**AGENDA
PUBLIC MEETING
REGULAR PLANNING AND ZONING MEETING
THE TOWN OF HORIZON CITY, TEXAS
Monday, September 21, 2026, 6:00 PM**

On the **Final Subdivision Plats** application for **Verdancia Unit 4 Phase I & II (Case No. SDF26-0002 and SDF26-0003)**, allow recording of the final plat prior to the completion of all required improvements secured by sufficient bond and to authorize the Mayor to sign the recording plat. Legally described as Being A Portion Of Section 30, Block 78, Township 3, Texas And Pacific Railway Company Surveys, El Paso County, Texas. Containing 86.51-acres ±. Application submitted by Applicant/Representative: CEA Group.

TOWN OF HORIZON CITY
Planning and Zoning Commission Staff Report

Attachment 7: Phase I & II Proposed Right-of-Way Cross Sections & Cul-De-Sac Design

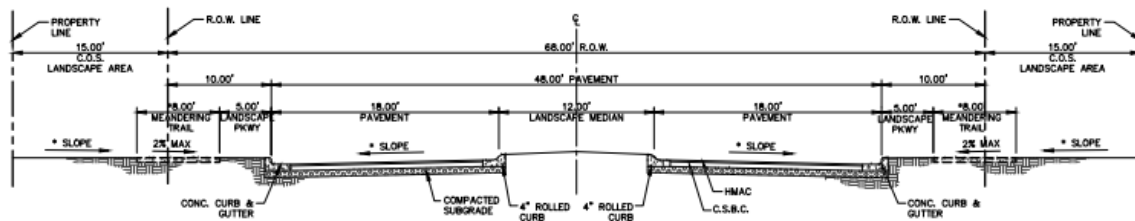
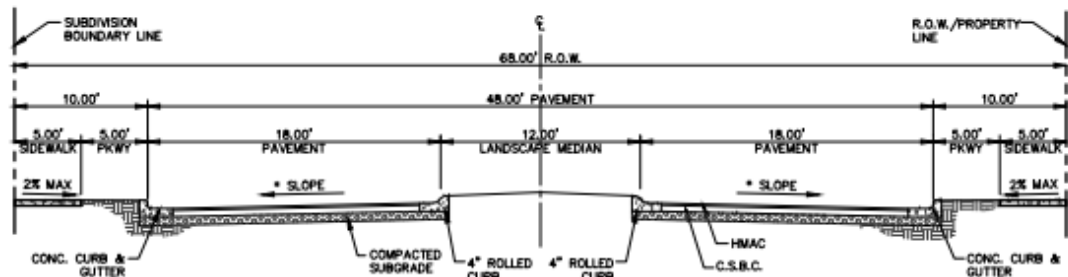
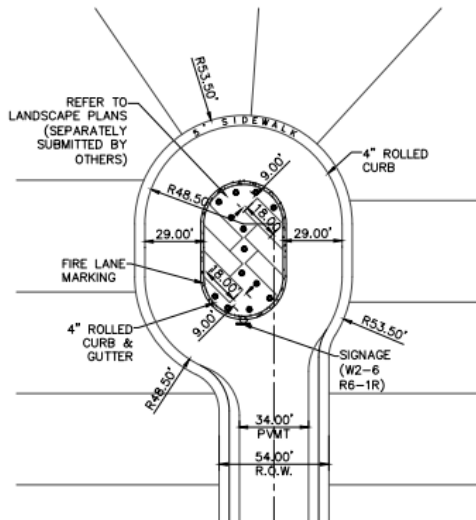
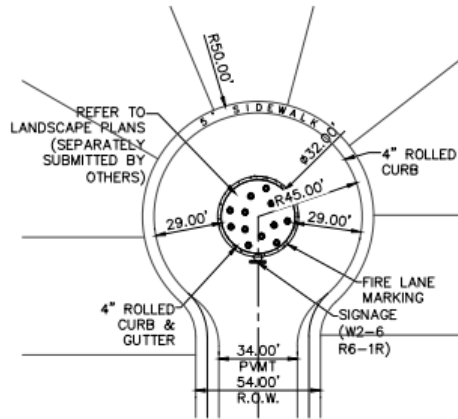
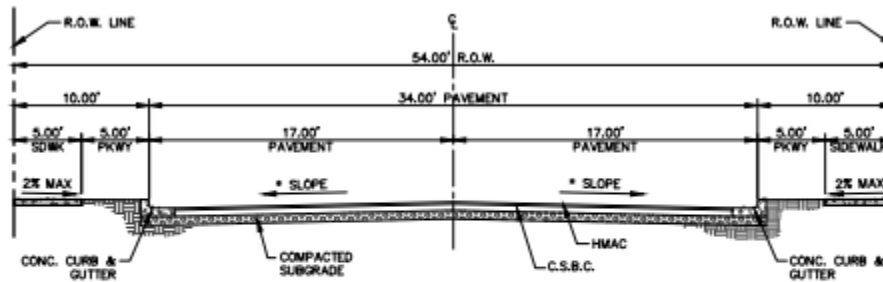
1. Modification from a 52-ft residential sub-collector street right-of-way to a 54-ft street right-of-way at all local residential sub-collector streets. The 54-ft street right-of-way will consist of two 5-ft parkways, two 5-ft wide concrete sidewalks and a 34-ft wide pavement structure with curb & gutter.

2. Modification to use a 68-ft residential collector at enhanced neighborhood entrances. The 68-foot street right-of-way will consist of two 5-ft parkways, two 5-ft wide concrete sidewalks, two 18-ft wide pavement structures and a 12-ft raised landscape median with curbs & gutter. Landscape areas will be maintained by the HOA.

3. Modification to use a 68-ft residential collector with meandering trails at enhanced neighborhood entrances abutting common open space lots. The 68-ft street right-of-way will consist of two 5-ft parkways, 36-ft wide pavement structure with curb & gutter, a 12-ft raised landscape median and two 8-ft wide meandering trails. The 8-ft trails will meander within the street right-of-way parkway area and the adjacent 15-ft common open space landscape lot. This will provide a visually appealing and safe walking trail along this corridor. Landscape areas will be maintained by the HOA.

4. Modification to use 50-foot radius Cul-de-Sac streets with interior landscape islands and outside travel lane roadway width of 29-feet. The proposed cul-de-sac and landscape islands will enhance the neighborhood character, reduce the impervious surface, aid to eliminate typical cul-de-sac "stack" parking and maintain adequate room for emergency vehicle turning movement. Landscape areas will be maintained by the HOA.
